Product Change Notification

Bourns® Model 70ABJ/Male Modular Contact *Change to Plastic Housing Design*

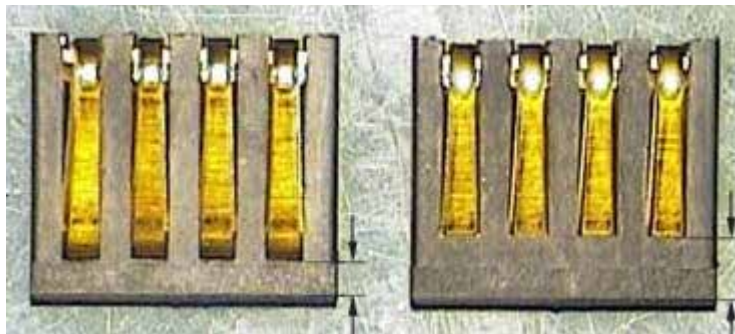
Below is the change in the plastic housing design. While the form has changed, the fit and function are completely the same and all of the overall dimensions are the same. Now, more plastic housing space will be available for automatic pick and placement on the board.

*Current Housing
(with Limited Space)*

*New Housing
(with Increased Space)*
